**TOWN OF NEWBURGH
PLANNING BOARD
TECHNICAL REVIEW COMMENTS**

PROJECT NAME: SCANNELL-NEWBURGH COMMERCE CENTER
PROJECT NO.: 2021-21
PROJECT LOCATION: SECTION 95, BLOCK 1, LOT 58
REVIEW DATE: 14 JANUARY 2022
MEETING DATE: 20 JANUARY 2022
PROJECT REPRESENTATIVE: LANGAN ENGINEERING

SITE PLAN APPROVAL DOCUMENTS FOR NEWBURGH COMMERCE CENTER

EROSION AND
SEDIMENT
CONTROL PLAN

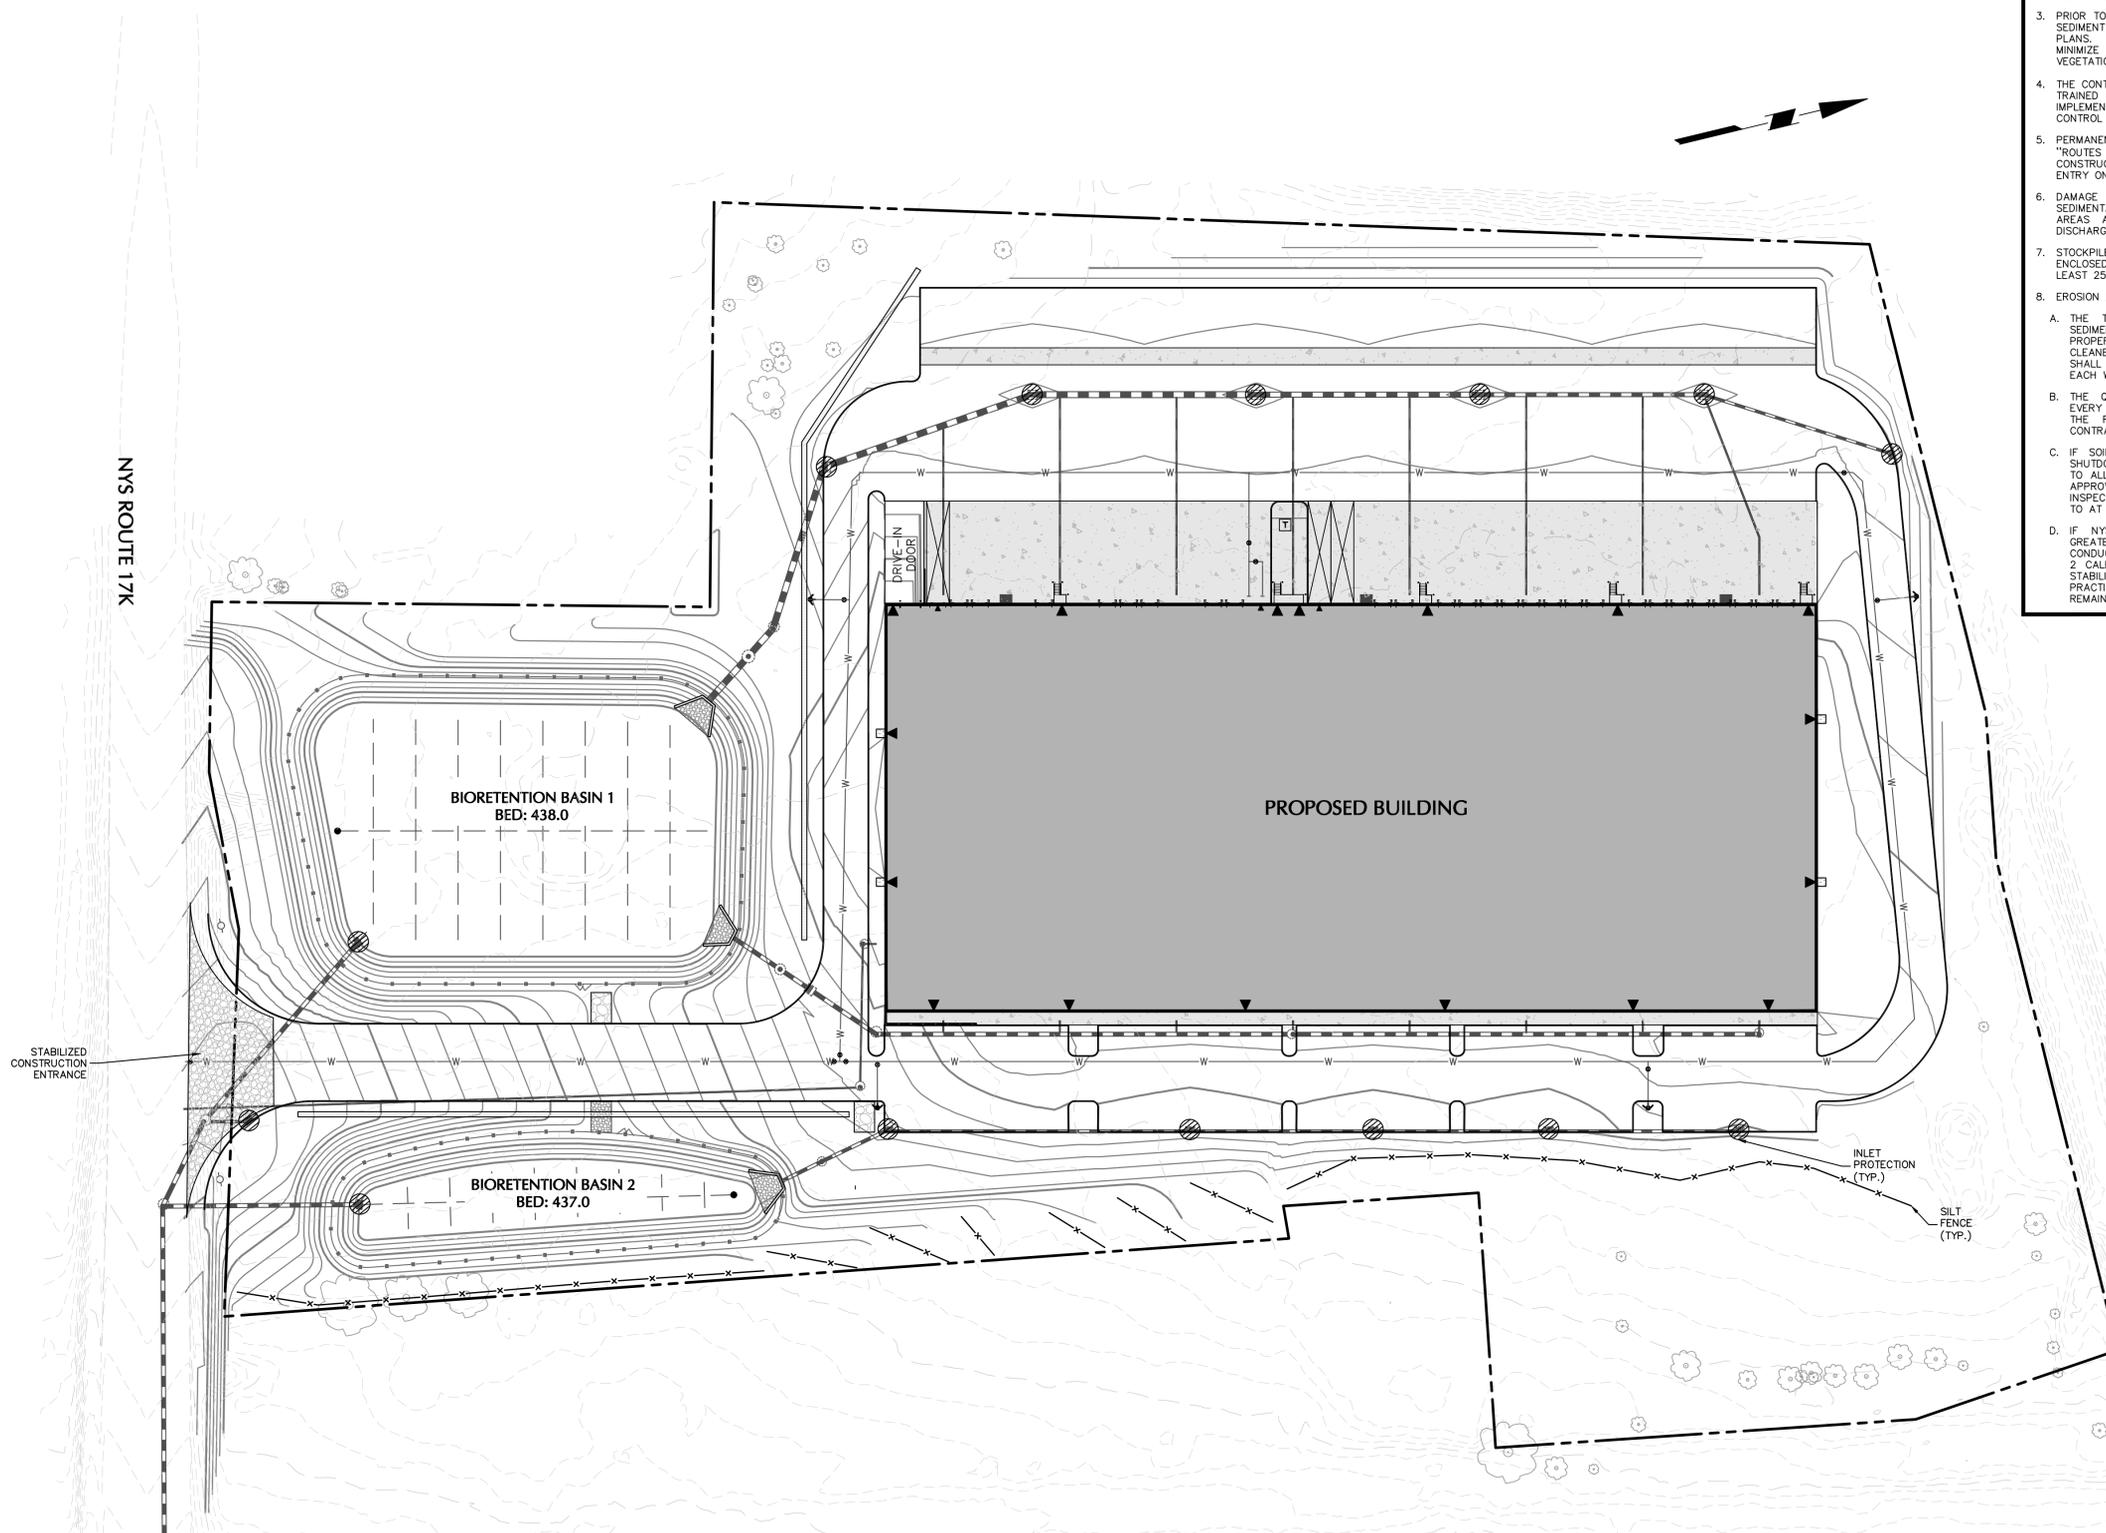
16. It is requested the Erosion & Sediment Control Plan address interim drainage condition along the easterly and westerly property lines existing and proposed grades.

17. It is unclear if temporary sediment traps are proposed on the plan. No detail or discussion of the same are provided. Volume of the temporary sediment traps should be calculated and identified.

CASCADE SEPARATOR (CS) WATER QUALITY UNIT
SCALE: NTS

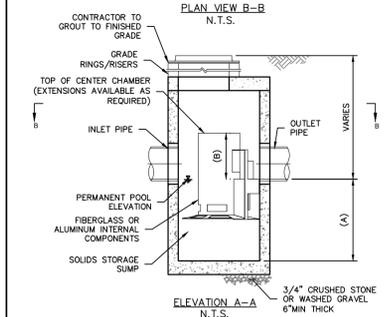
12. The Narrative portion of the SWPPP should identify the use of the proprietary pre-treatment units prior to discharge to the bio-retention basins.
13. The location of the natural discharge for headwall #17 should be identified on the plans. The drainage course between this point discharge and the natural stream should be provided. The velocity of this discharge point should be evaluated as the pipe slopes are approximately 5% to 5.5% grades along the 17K corridor.

BIORETENTION 1 OUTLET CONTROL STRUCTURE OCS-22
SCALE: NTS

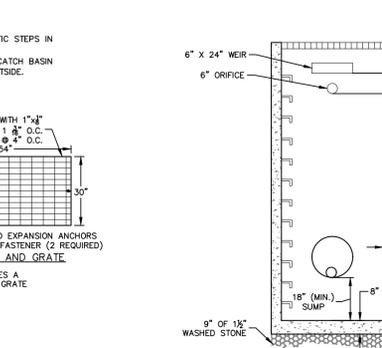
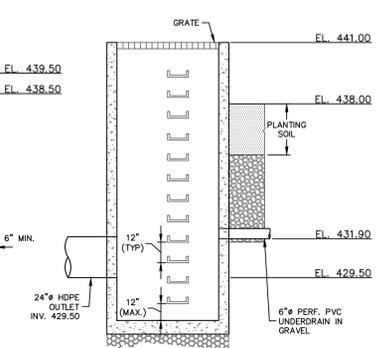
9. A Stormwater Facilities Maintenance Agreement will be required to be executed and filed with the Town and with County Property records.
10. Two bio-retention areas are proposed for water quality control. Bio-retention area #1 is identified as having a liner while Bio-Retention area #2 is identified as not being lined. Bio-retention area #1 addresses the hot spot areas of the site while bio-retention area #2 takes on a roof and passenger vehicle parking. Two separate details should be provided on the plans.

11. It is noted in the Stormwater Model that bio-retention area #1 identifies a .25 inches per hour exfiltration in the calculation. This is a lined pond which also then takes credit for the six inch vertical underdrain.
